SCHEDULE OF AMENDMENTS

rev:	date:	description:
scale:	1:250	A1 date: 24 / 09 / 2024
drawing no:	1277 / P3 / 1	drawn: TF
drawing:	SITE LAYOUT PLAN, STREET SCENE, AND LOCATION PLAN (PROPOSED)	
project:	PENNY WOOD, HOLLYBUSH RIDE, FINCHAMPSTEAD, WOKINGHAM, RG40 3OP	
client:	MRS JIA QI LI

SITE LAYOUT PLAN (AS BUILT)
SCALE 1:250

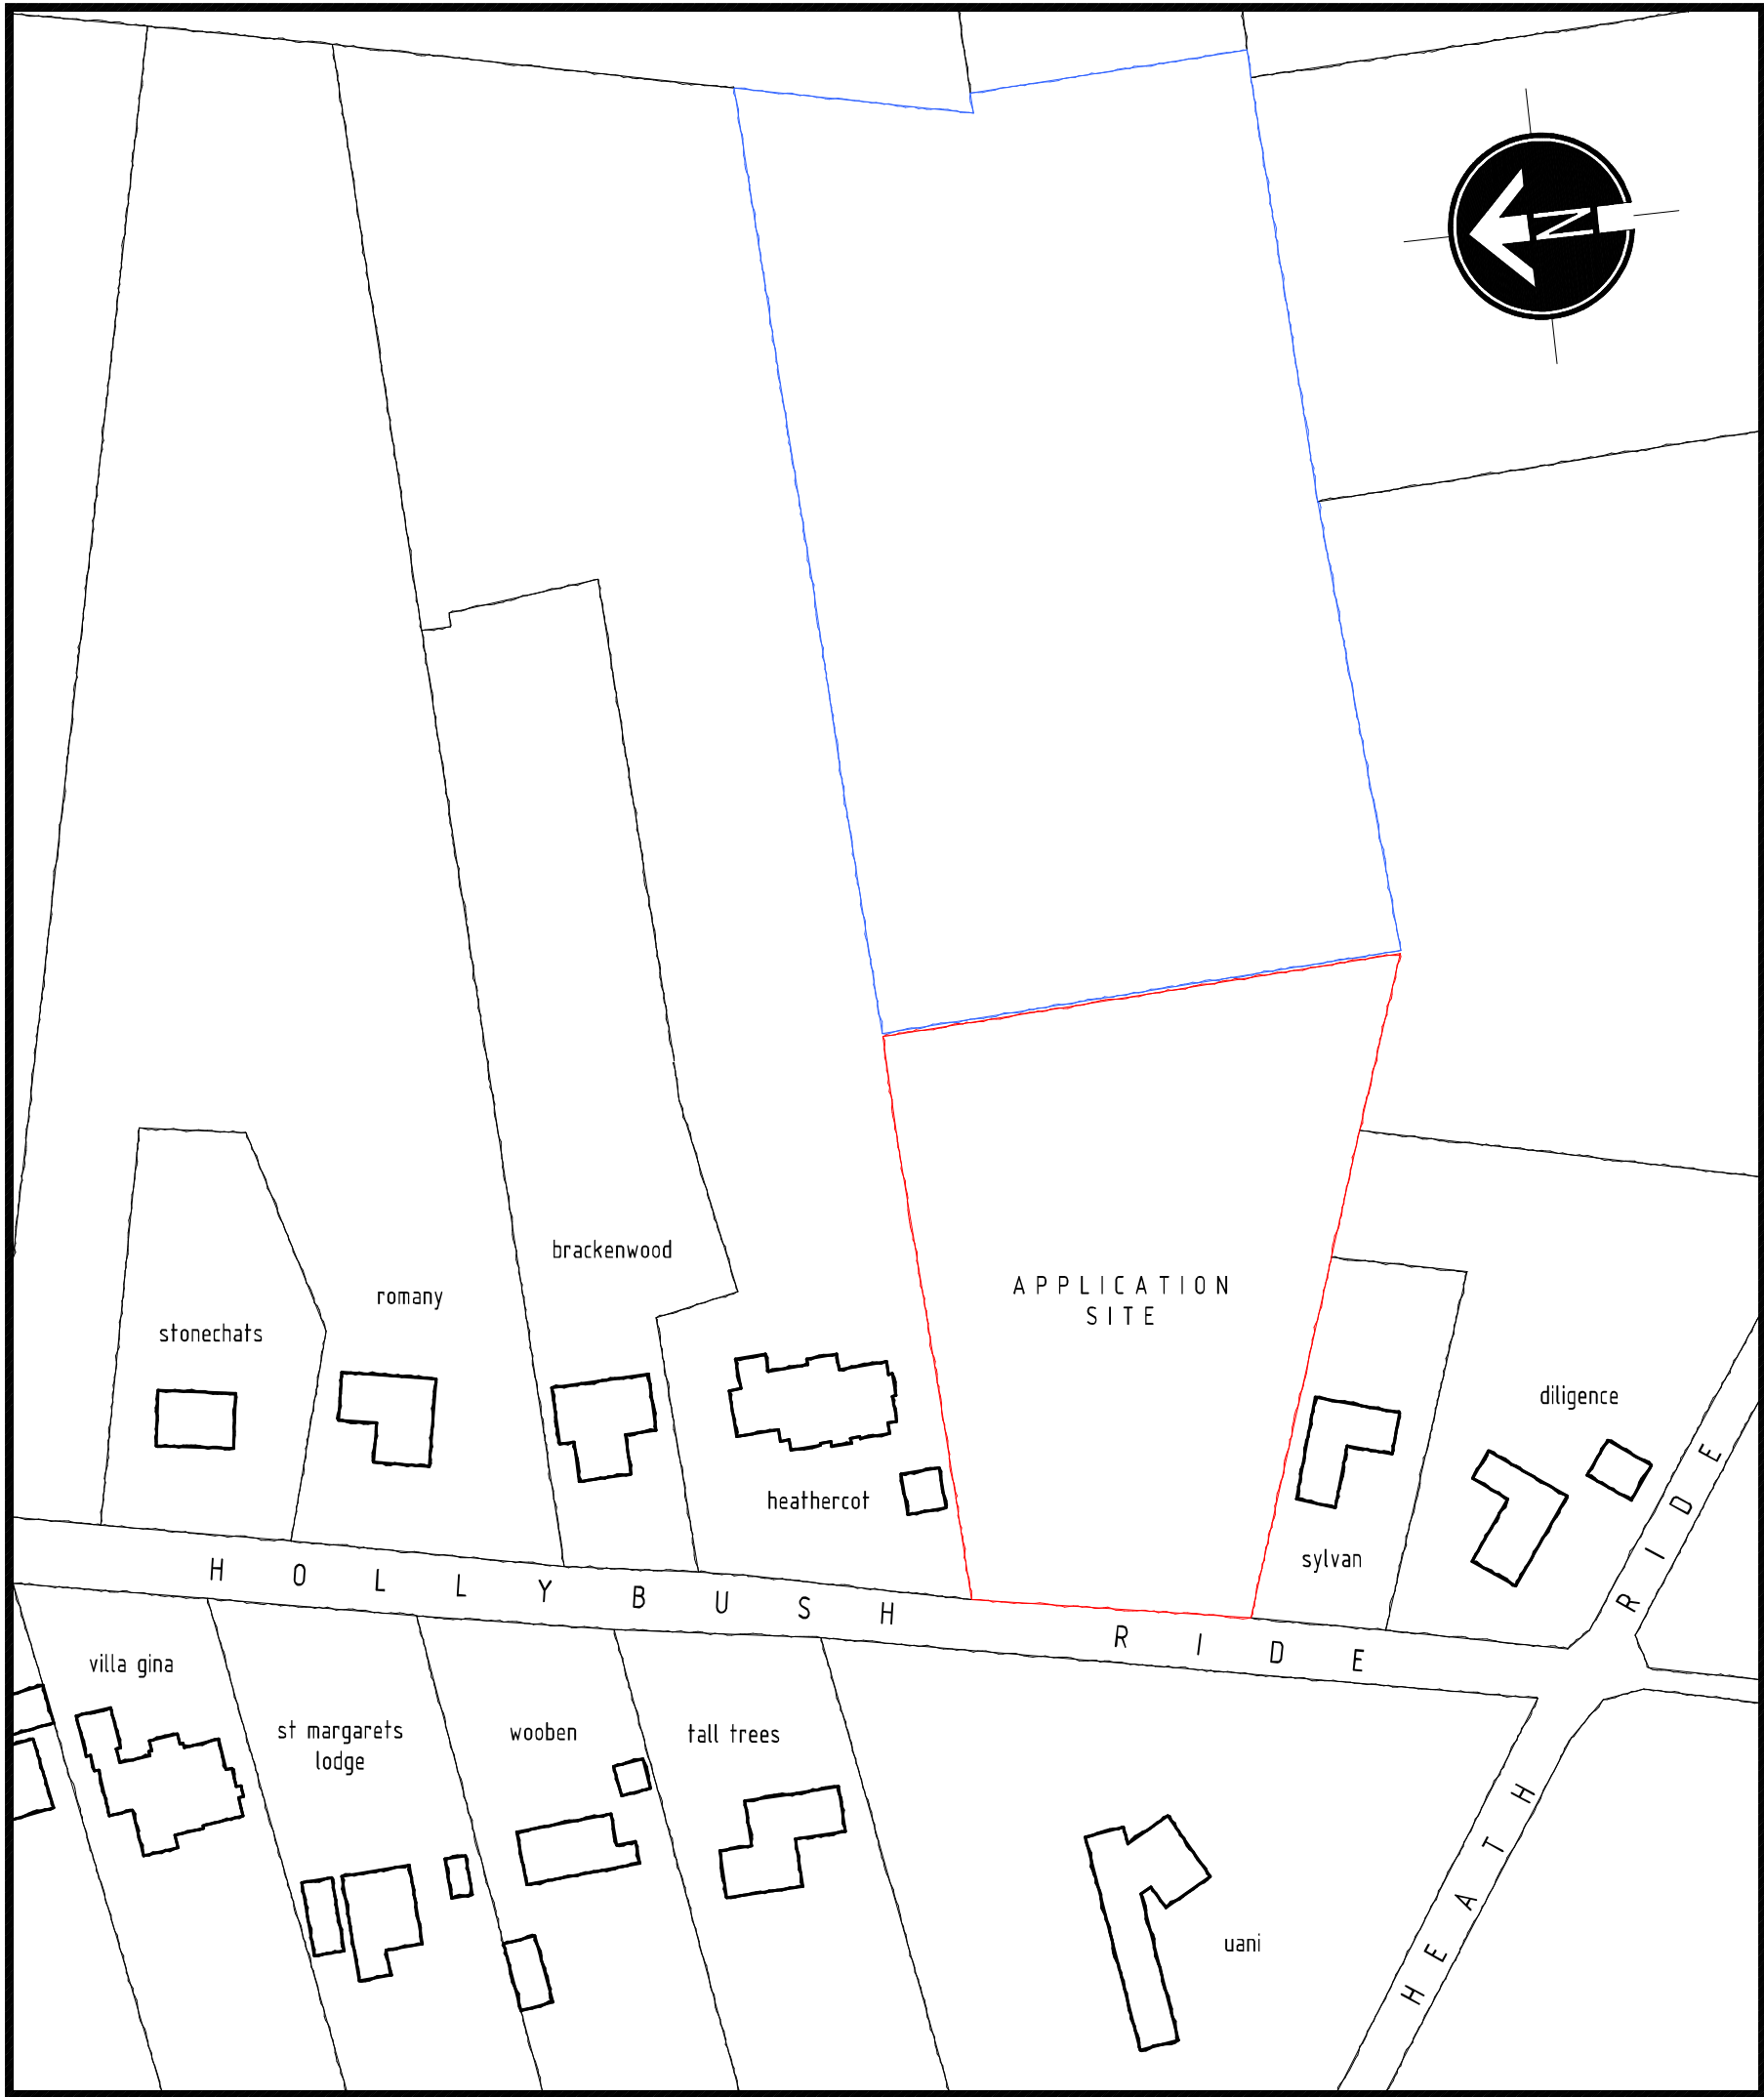
- A. Entrance gate, piers and fence amended (increase in height, pedestrian gate added and railings replacing timber fence).
- B. Flower bed feature added to front drive.
- C. Driveway extended (down right hand side of dwelling).
- D. Rear patio indicated.
- E. Pergolas added to rear patio.

- F. General changes to fenestration design and material (from timber frame to aluminium frame).
- G. Change to window and door surrounds (from brick to stone).
- H. Change of rear dormer roofs (from pitched to flat).
- I. Change to detailing of portico.
- J. Change to roof ridge and hips detailing (half round to angled).
- K. Change to front gable detail (fascia replacing brick detailing).
- L. Rear parapet raised slightly to allow for flat roof falls.

- M. Additional dormer added to front elevation.
- N. Velux added to rear elevation.
- O. Roof form amended to be gable ended.
- P. External metal staircase added (and door).
- Q. Garage door centralised.
